DEVIATION REVIEW AND DECISION FORM

Subdivision or Project Name: Springs at Waterview

Section of ECM from Which Deviation is Sought: 2.2.5.D.1

Proposed Nature and Extent of Deviation: Request for interim three-quarter movement (left-in/right-in/right-out) access point to Bradley Road approximately 505 east of Grinnell Boulevard (centerline spacing) to provide a second access to the proposed residential development north of Bradley Road. The Collector classification of Bradley Road in this location is per the approved Sketch Plan. The three quarter access is labeled as "interim" because the applicant is agreeable to the access being restricted in the future to right-in/right-out if Bradley Road is connected between Powers and Goldfield Drive.

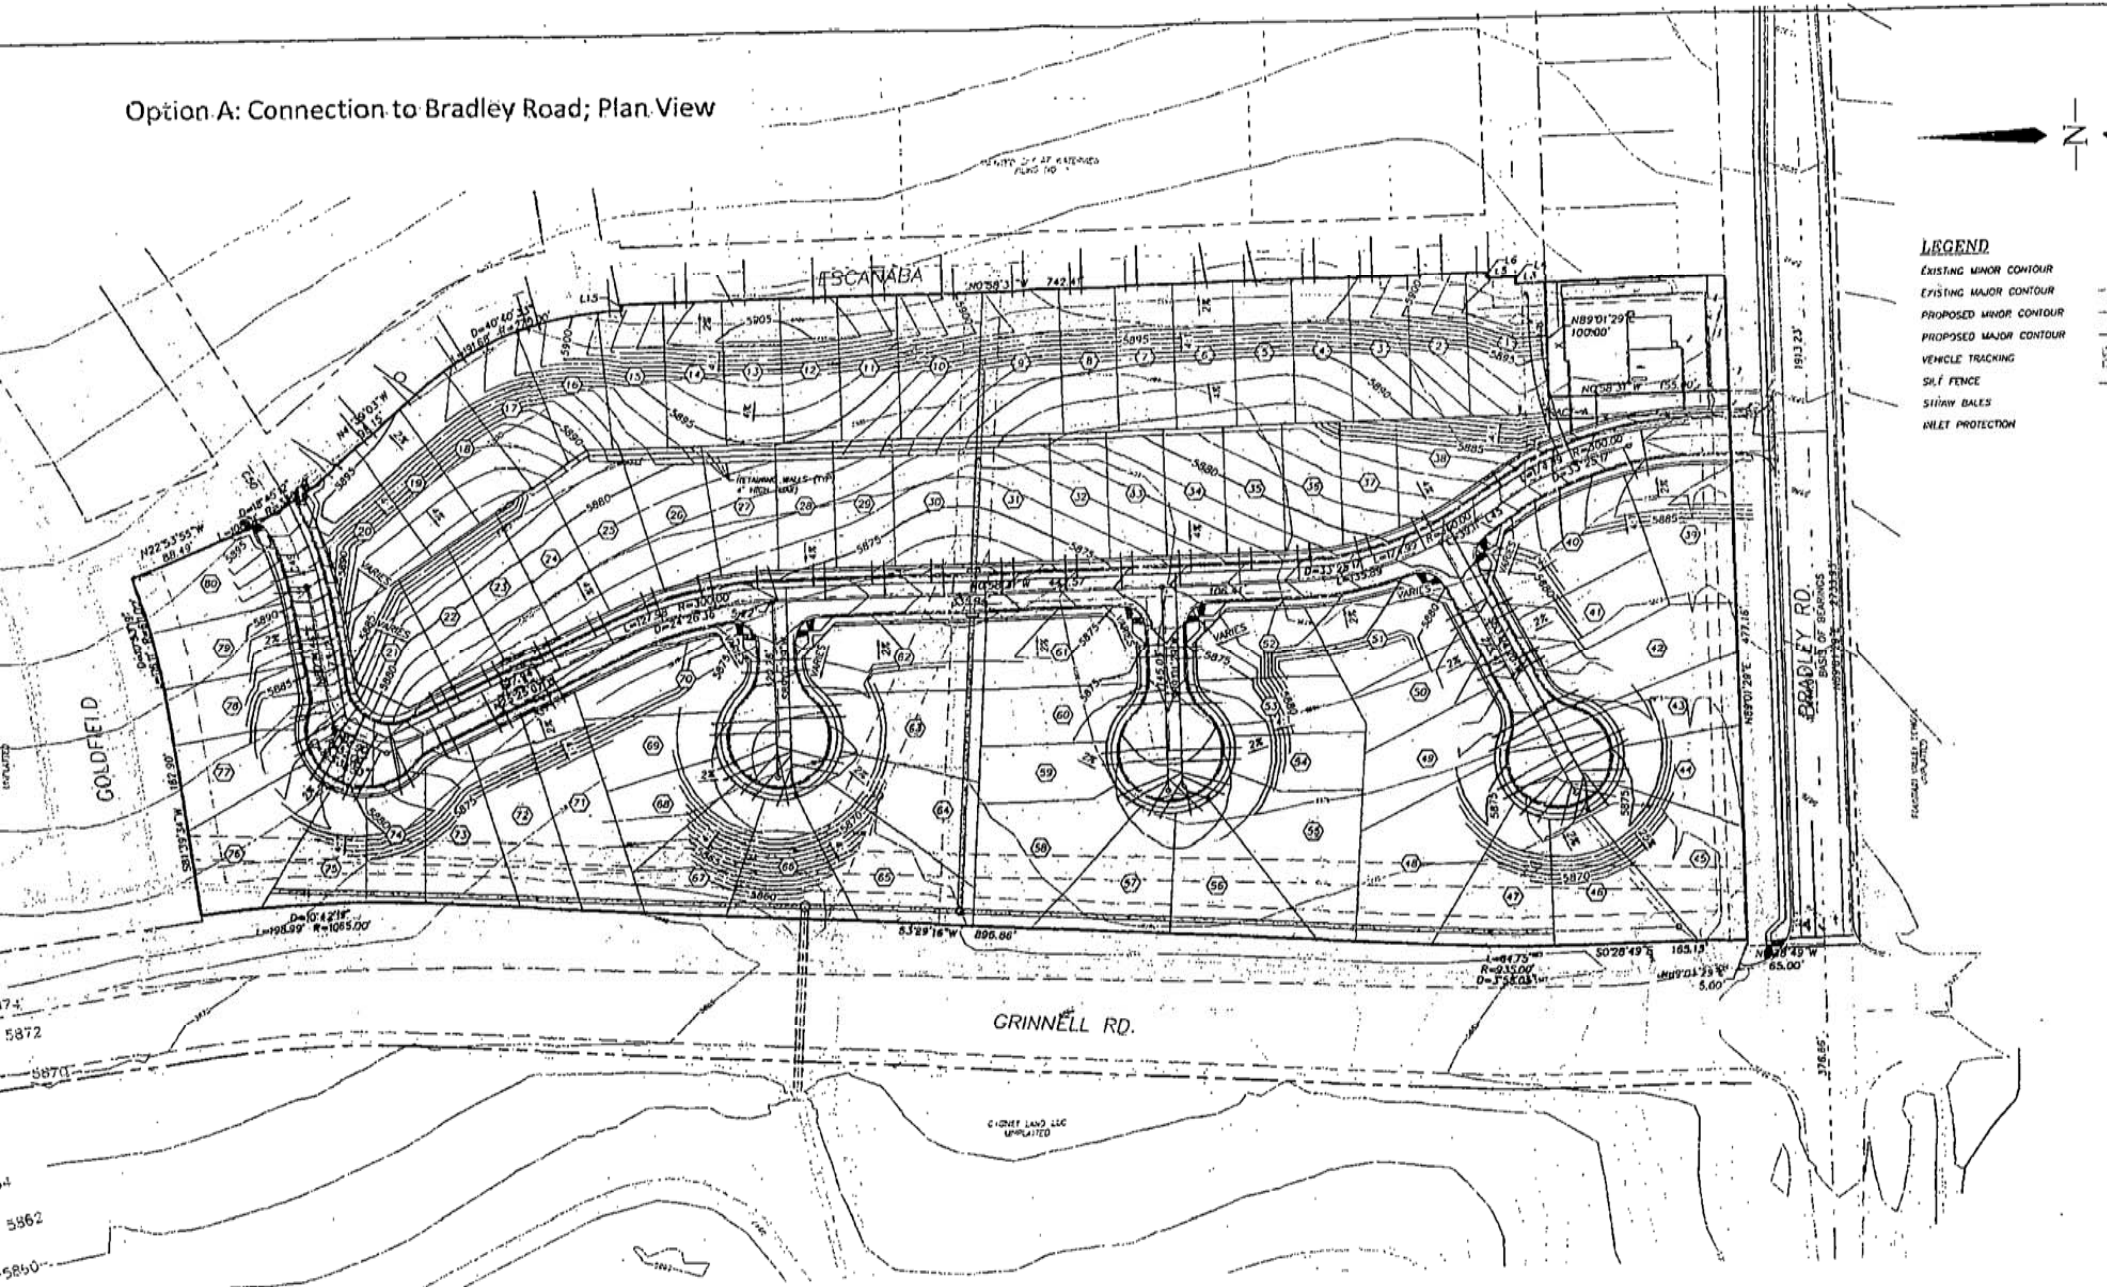
Review and Recommendation:
APPROVED by the ECM Administrator W/CAUTION NOTED BELOW.

This request has been determined to have met the criteria for approval. A deviation from Section _____ of ECM is hereby granted based on the justification provided. Comments:

X CONDITION OF DEVIATION APPROVAL:
3/4 ACCESS MAY BE FURTHER RESTRICTED IF BRADLEY ROAD IS CONNECTED BETWEEN POWERS BLVD & GOLDFIELD DRIVE OR AS DETERMINED BY THE COUNTY ENGINEER.
____ Additional comments or information are attached.
